**APPLICATION FOR PERMIT TO DRILL AND CONSTRUCT
AN UNCASD CATHODIC PROTECTION BOREHOLE**

Permit Application Number CPB- 60

Aquila
4th & Hendricks
Hutchinson, Reno County, Kansas
October, 2007

Re: Application Nos. CPB-57, CPB-58, CPB-59, CPB-60 – Aquila Gas Distribution Main

CATHODIC PROTECTION BOREHOLE ILLUSTRATION

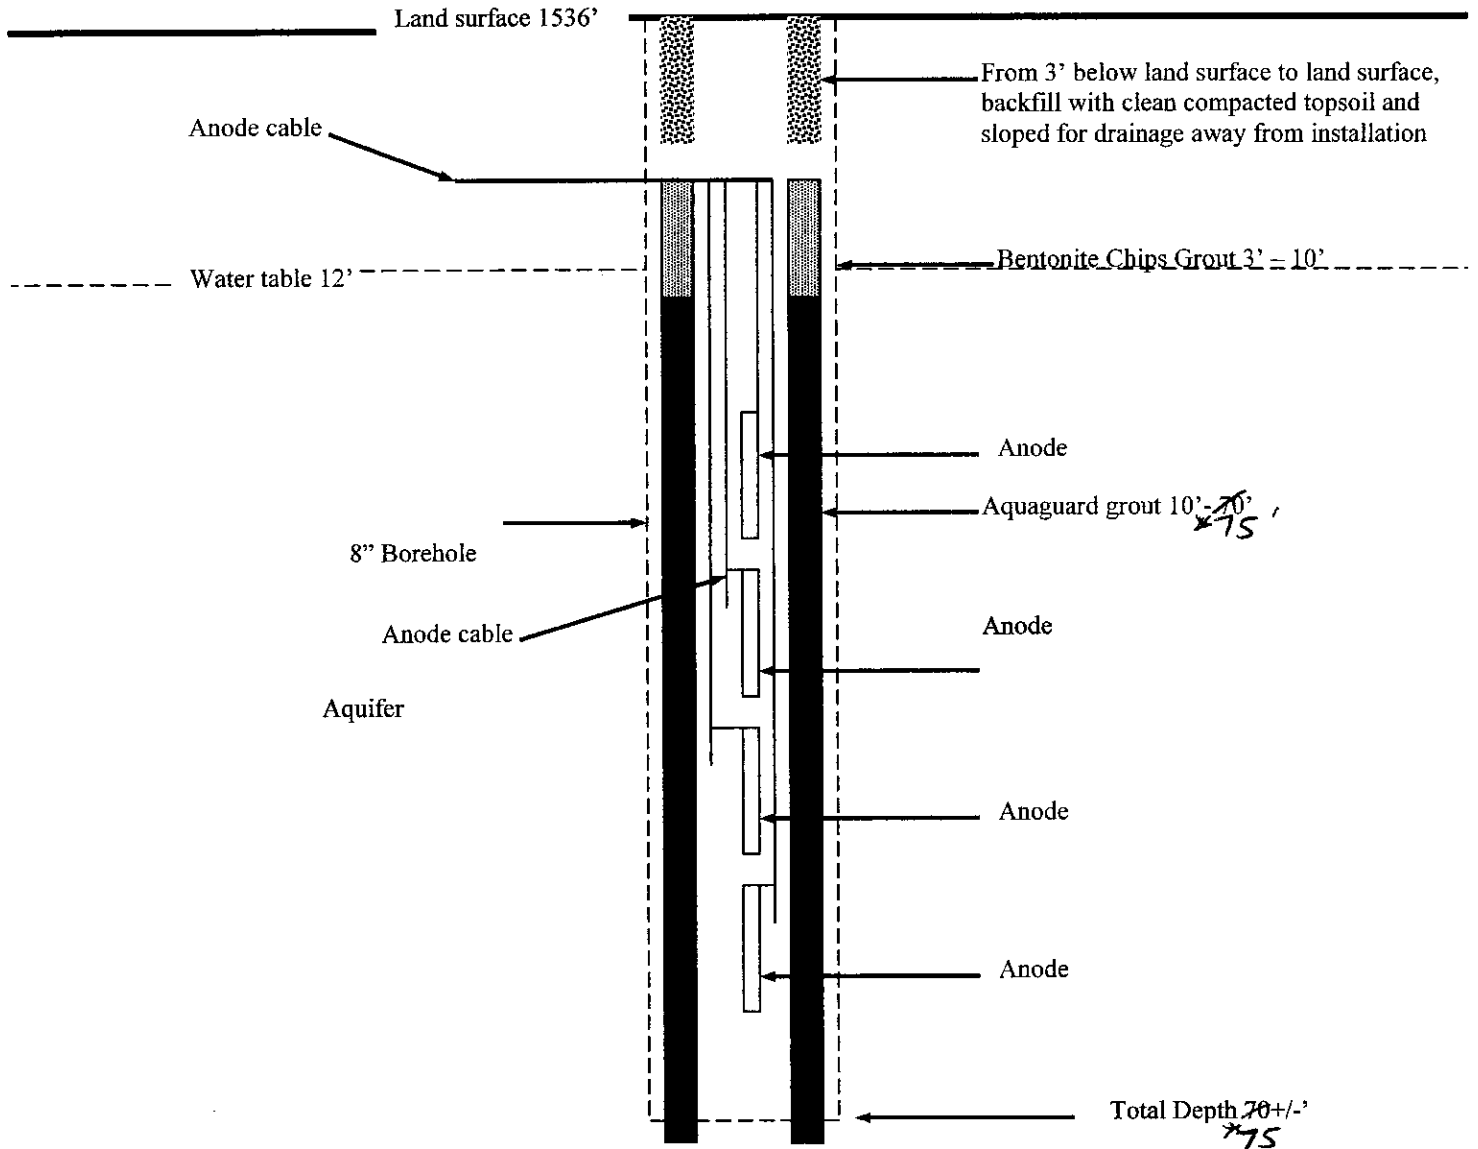
X TDS per D.I.R
H. 11-13-07

During the review, the applicant requested the following modifications be made to each application: 1) paragraph #4 change the depth to top of bedrock/shale to 75 feet below land surface, 2) paragraph #7 change the borehole completion depth to 75 feet below land surface, 3) paragraph #10 change to anode conductor grout (Aquagard) being installed from 10 feet below land surface to total borehole depth of 75 feet below land surface, and 4) change the illustration to reflect the application parameters.
